Steven H. Emerman, Ph.D.
Specializing in Groundwater and Mining

October 30, 2020

I am writing in response to your questions regarding the next steps following our meeting with USGS. I would first like to try your attention to the follow-up e-mail that I received from Jimmy Clark with the image below:

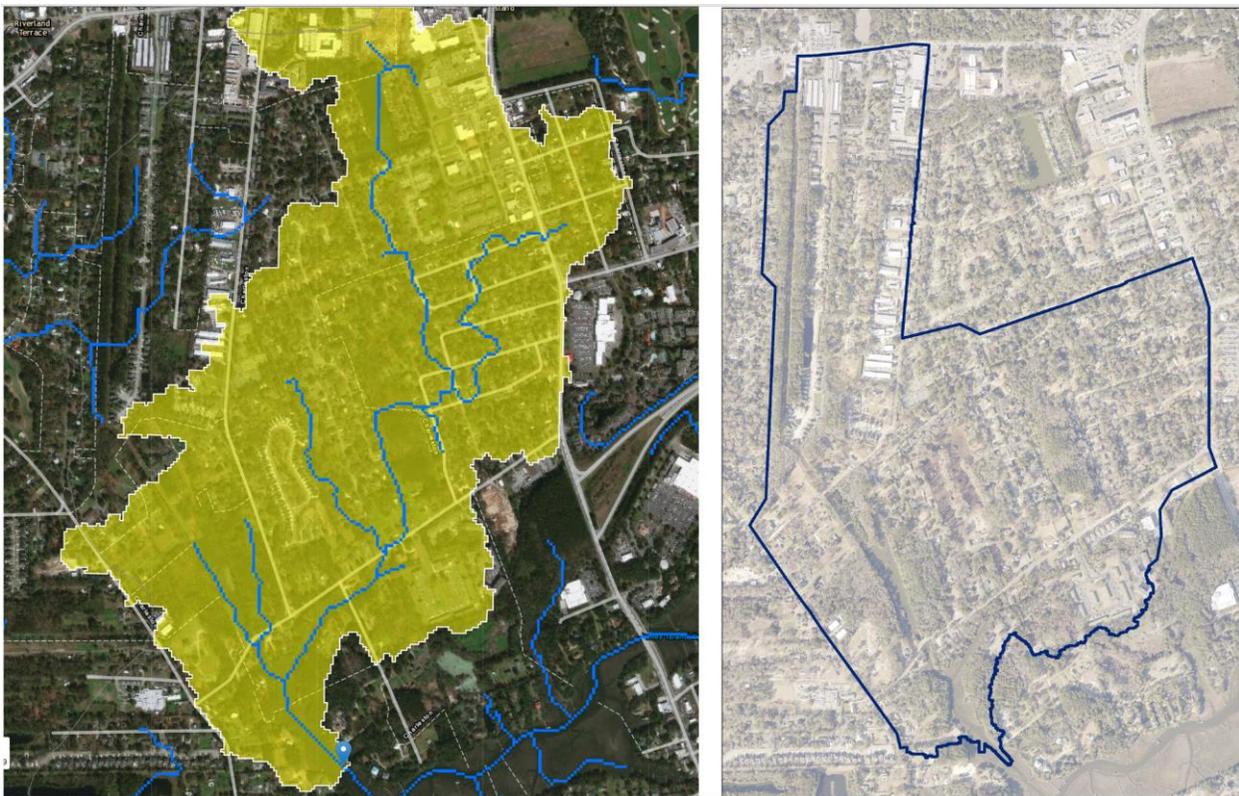
The map on the right is the Central Park watershed as delineated by the AECOM drainage study. The map on the left is the Central Park watershed as delineated by the online USGS tool StreamStats. If StreamStats is correct, then the AECOM stormwater model is so inaccurate that it does not even use the correct boundary to the watershed. In fact, if StreamStats is correct, some

of the stormwater infrastructure improvements recommended by the AECOM study (Area 4 Improvements) are not even in the Central Park watershed.

I had always known about the StreamStats tool, but I had assumed that the AECOM study would be more accurate because it was based upon the 2017 Lidar data and incorporated small-scale engineering reports and fieldwork. However, this was the response from Jimmy Clark, “While they [AECOM] did use the newer 2017 lidar derived data, I wouldn't expect the difference seen. It's possibly from missing connectors such as culverts or ditches linking the actual drainage system. Though far from perfect, we took great pains to accurately account for these connectors as part of our 2014-2018 study with the SCDOT to implement StreamStats for SC. Also note the part of their drainage area shown in the NW quadrant of their study area map draining to James Island Creek actually is showing up in StreamStats as being part of the Stono River drainage area.”

This is why I am very hesitant to charge forward with constructing stormwater improvements based on the recommendations of the AECOM study without quantitative verification of the AECOM stormwater model and without a method of quantitative evaluation of the outcomes of the stormwater improvements.
